11/17/01 Review of Dynamic soil properties from G(P018)-2

Soil Calculations for PFS
For CTBDynamic Soil Properties from G(PO18)-2 Table 7
Upper Range

Soil Calculations for PFS
For Storage Pads

REVIEW OF STORAGE PAD ANALYSIS

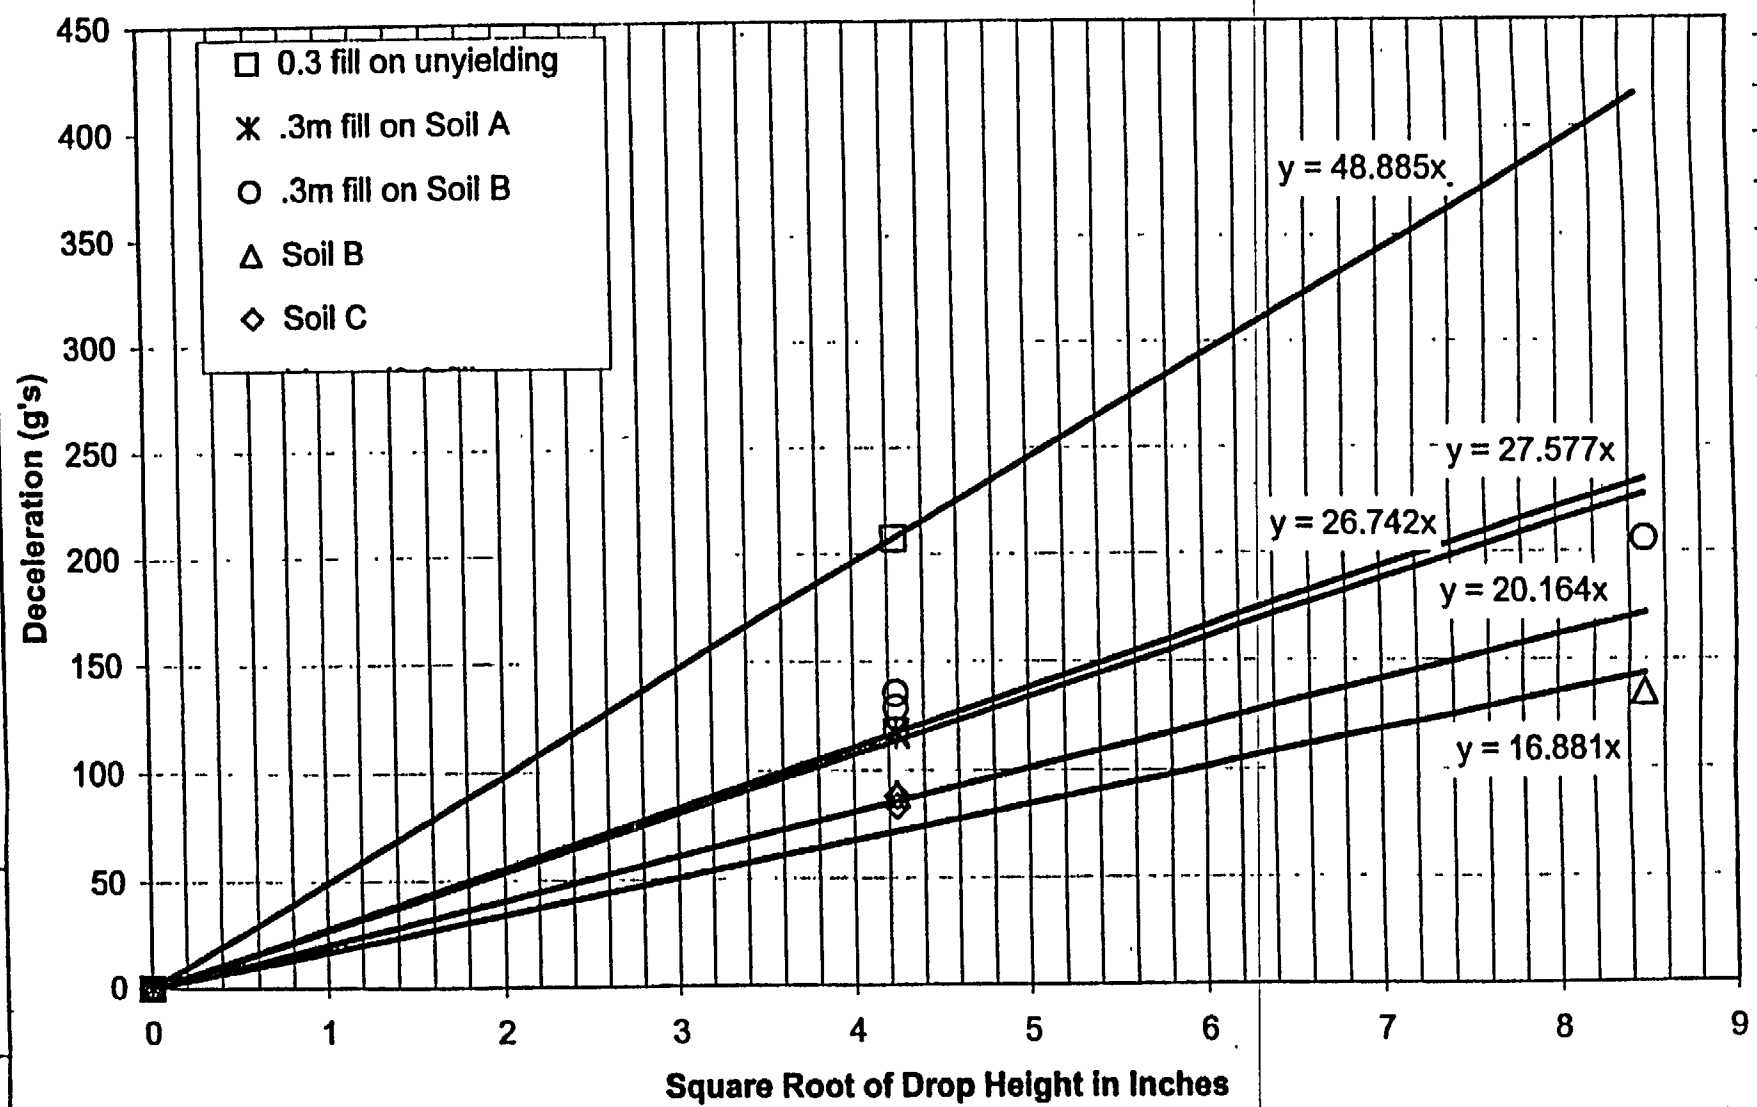
The test results were plotted using Microsoft Excel.

The resulting data indicates that the peak deceleration

is proportional to the square root of the drop height.

DJP
11/19/01
This corresponds to the fact that the deceleration is proportional to the energy at impact and the stiffness of the system.

A linear regression analysis of the data in NUREG/CR-6608 was performed and plotted (see page 17)

Summary of Results from NUREG/CR-6608

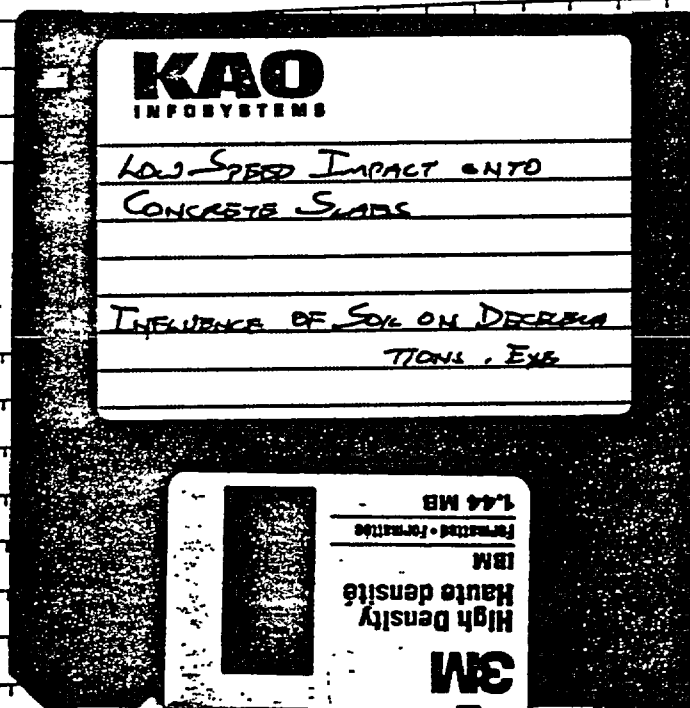
11/19/01
The data indicates that the deceleration for a specific impact ^{on 11/19/01} condition ~~that the~~ is proportional to the square of the drop height. This correlates to the information provided on page 12 of Holtec HI-2012653 Revision 2.

There is a slight dependence on the type of soil.

There is more change due to the addition of engineered fill
